**RESPONSE TO REQUEST FOR ADDITIONAL INFORMATION**

**US-APWR Design Certification**

**Docket No. 52-021**

**RAI NO.:** NO. 212-1950 REVISION 1  
**SRP SECTION:** 03.07.02 - Seismic System Analysis  
**APPLICATION SECTION:** 3.7.2  
**DATE OF RAI ISSUE:** 02/25/2009

**Figure 1. Grouping for Seismic Coefficient Analysis**

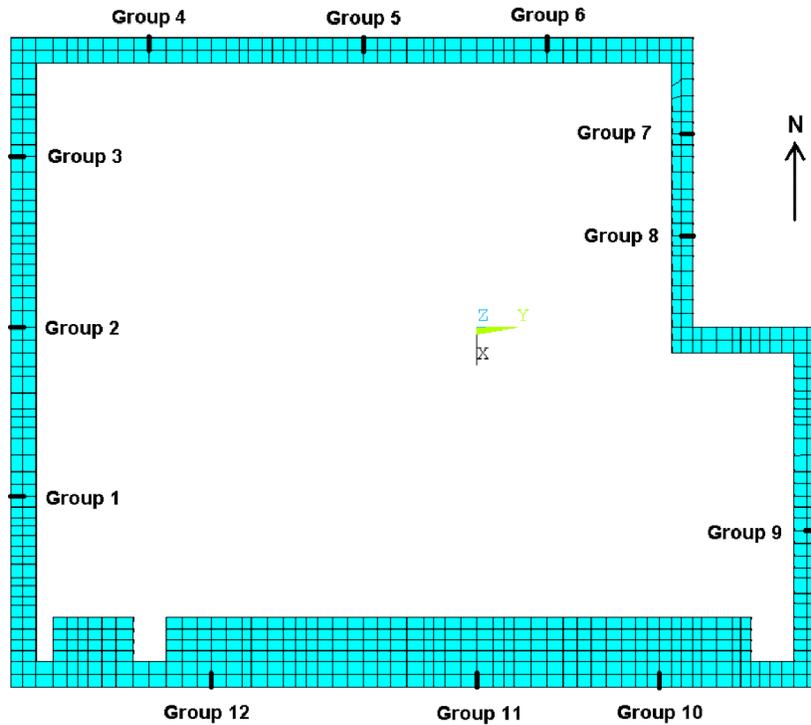
It is stated in Section 3.7.2.8 of the DCD that dynamic increases in seismic lateral earth pressure on below-grade exterior walls were accounted for in the design of the USAPWR Seismic Category I structures by applying conservative maximum static and dynamic lateral pressure profiles in accordance with ASCE 4-98. The staff has not reviewed and endorsed ASCE 4-98 for this application. Currently this ASCE standard is under revision. Describe the pressure distribution profiles and the application of these pressure profiles to below-grade exterior walls in the seismic models, and what models are affected. Explain the basis for determining the lateral pressure distribution profiles to be conservative.

The saturated unit weight of 130 pcf of the backfill soil is used assuming that the pore water moves together (in-phase) with the soil during earthquake shaking, and the inertial force is proportional to the total weight of the embedment soil. This assumption is conservative since it does not consider the dissipation of energy due to the viscous flow of the ground water in the soil skeleton. The soil-structure interaction (SSI) and structure-soil-structure interaction (SSSI) analyses of the fully embedded reactor building (R/B) complex result in a maximum average horizontal acceleration of 0.499g (as shown in Table 1) along the embedment depth for 12 selected vertical sections through the backfill in the vicinity of the basement walls, denoted as Group 1 through Group 12 in Figure 1. Therefore, a value of 0.5 is used for the horizontal seismic coefficient.
